Subject: Docket 50-156, License R-74
License Amendment Request Regarding Administrative Controls
Proposed Changes to Technical Specifications

Attachment 1

Proposed Changes to Technical Specifications

4. Technical Specification Figure TS-1 is currently represents the Organization Chart as shown below:

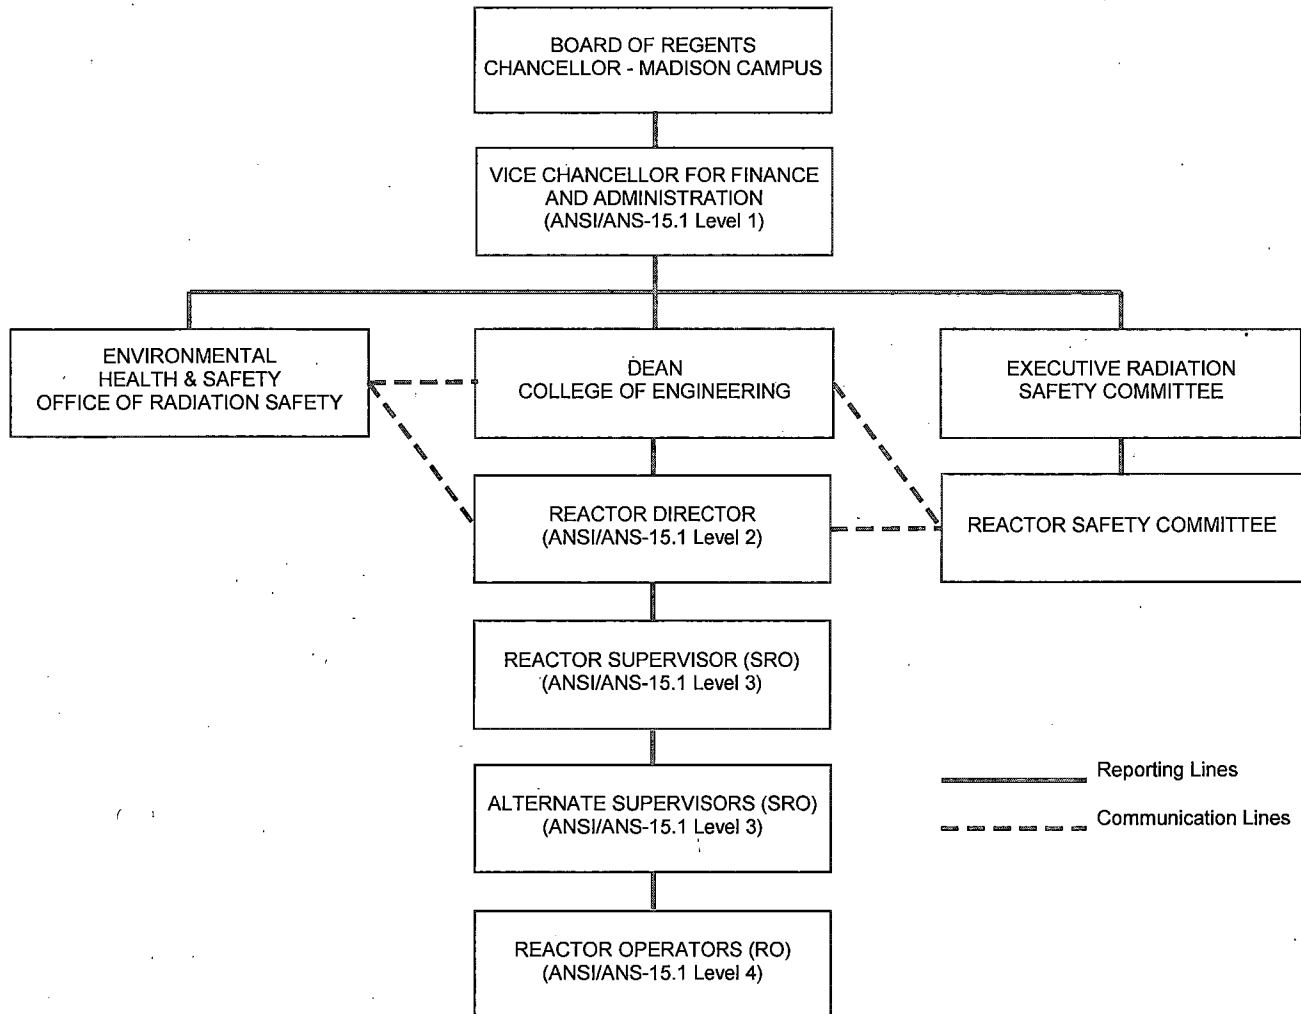
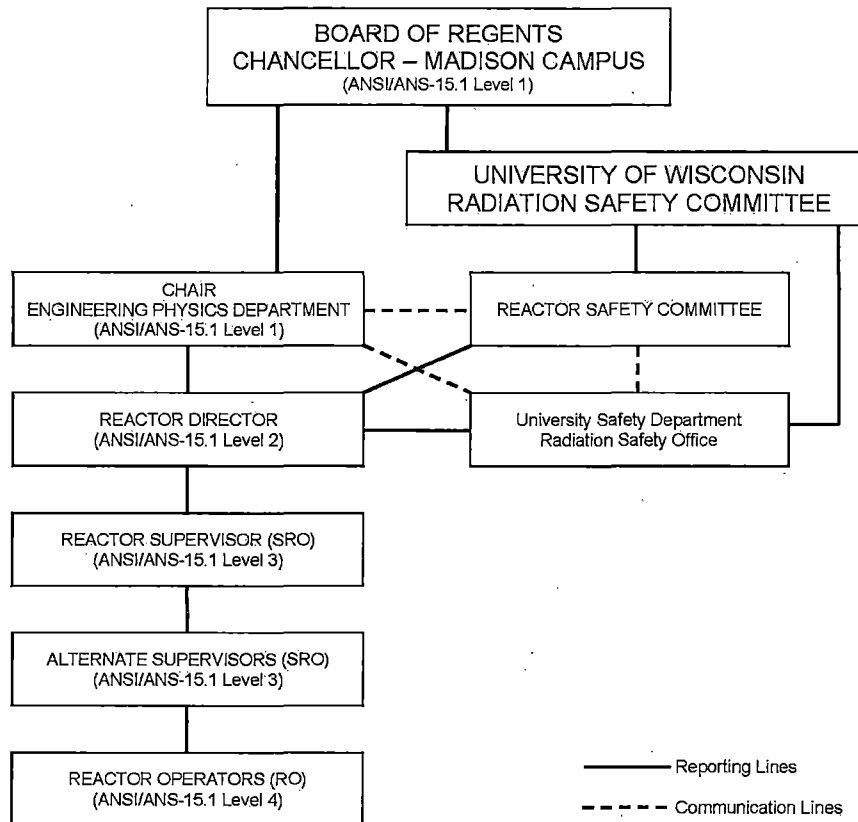
It is proposed to replace the Chair of the Engineering Physics Department with the Vice Chancellor for Finance and Administration and insert the Dean of the College of Engineering as represented below:

The basis for the replacement of the Chair of the Engineering Physics Department with the Vice Chancellor for Finance and Administration has been previously addressed in item 1 above.

The basis for the addition of the Dean of the College of Engineering has been previously addressed in item 1 above.

As required ANSI/ANS 15.1 section 6.1.1 the structure of the review and audit groups (the Reactor Safety Committee and the Office of Radiation Safety) as well as their reporting path are to be clearly identified including how these groups report to Level 1 management and communicate to Level 2 management.
